Service Letter No. 359

SUBJECT: Modification of Fuel Cell Vent Tubes

MODELS AFFECTED: PA-23 Apaches - Serials 23-1 to 23-1026 inclusive

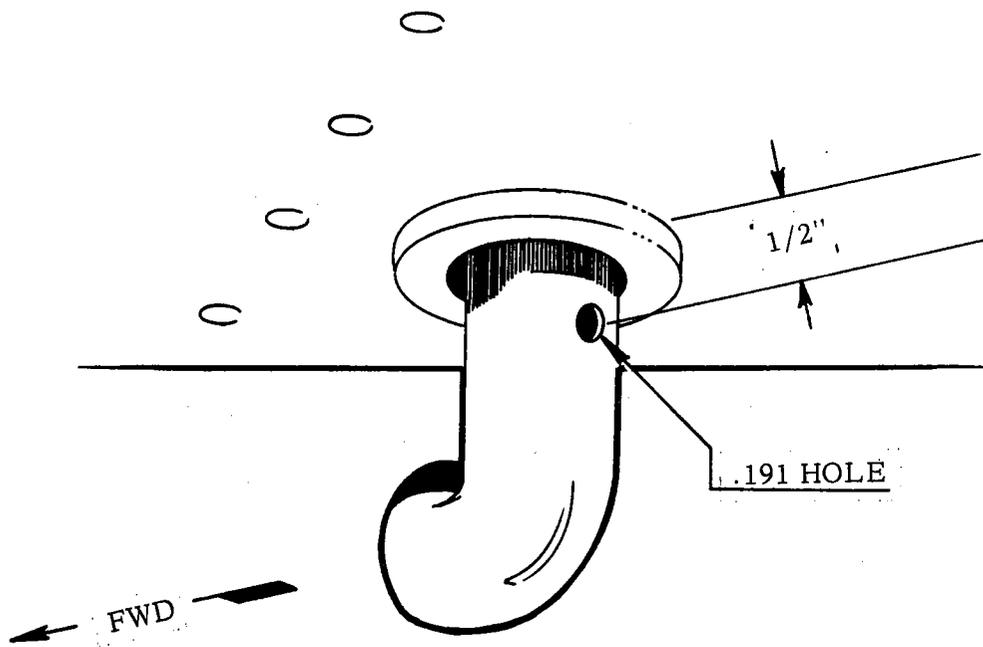
Due to the design of the fuel cell vent tubes on the above mentioned aircraft, there is a possibility of water collecting in the vent tubes and forming ice at freezing levels. Foreign particles may also become lodged in these tubes.

Restriction of the fuel cell venting action may follow.

It is requested that the fuel cell vent tubes be modified as follows:

Drill a .191 hole in the aft side of each vent tube at a point 1/2" down from the bottom wing skin, as shown in the sketch on the reverse side of this Service Letter.
